Subject: USNRC Docket No. 72-1014, TAC L23850
HI-STORM 100 Certificate of Compliance 1014, Proposed Amendment 5

Via e-mail on August 31st (Reference 2), the SFST staff identified an apparent discrepancy in the Proposed Revised FSAR previously submitted in support of Proposed Amendment 5 to the HI-STORM 100 Certificate of Compliance. Holtec has investigated the apparent discrepancy and determined that Table 2.0.1 contained an incorrect maximum stainless steel design temperature. This value was "rolled back" from 1200°F to 950°F in other sections of the FSAR in response to an earlier SFST request (Reference 3), but was inadvertently left in this one table. It was agreed, in a teleconference on September 5th (Reference 4), that this oversight would be corrected. A replacement page is attached (Attachment 1).

Via teleconferences on August 30th and September 6th (References 5 and 6), the SFST staff requested several editorial changes in Appendices A and B to the Proposed Revised Certificate of Compliance. The minor modifications requested include:

Figure 2.1-1
Fuel Loading Regions - MPC-24

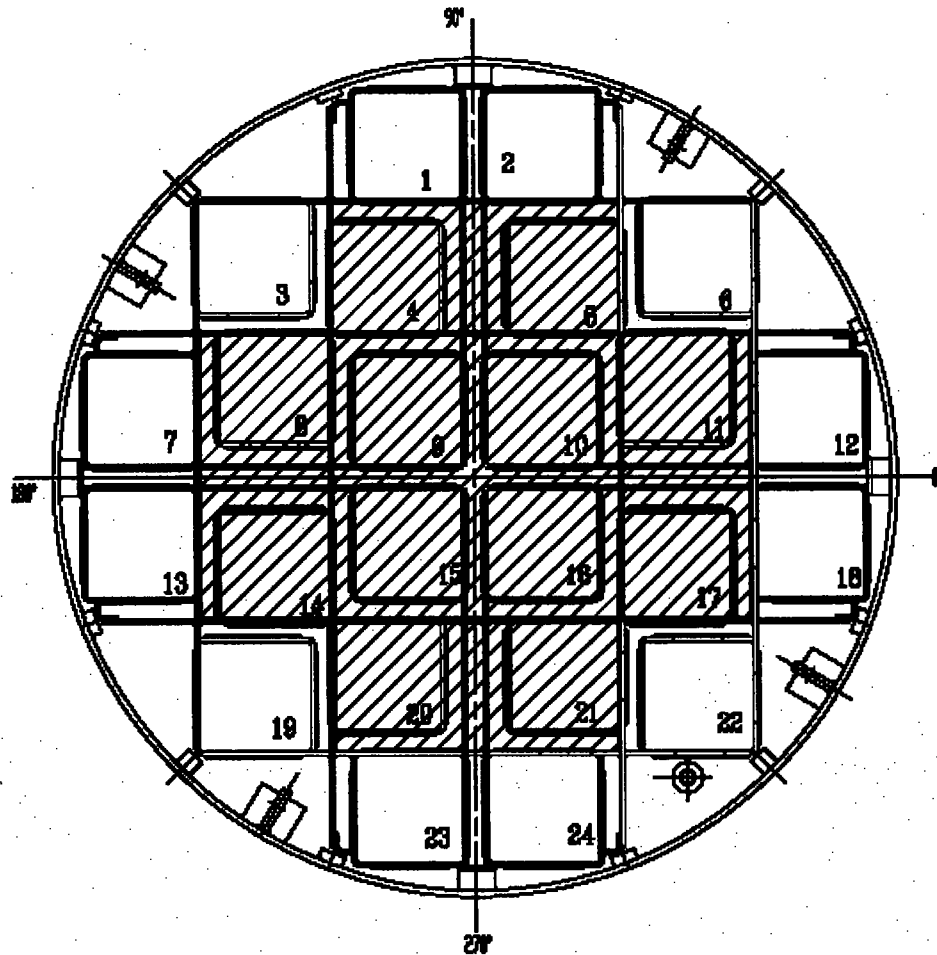
1. Slight rewording to ensure that definitions in both Sections A1.1 and B1.0 are identical
2. Corrections to the Region 1 "hatching" in Figures B2.1-1 and B2.1-2
3. Correction of the title of Section IV of Table B2.1-1
4. Correcting the allowable locations for NSAs in Note 1 in Section V of Table B2.1-1
5. Correction of a typographical error in the equation for q_2 in Section B2.4.2
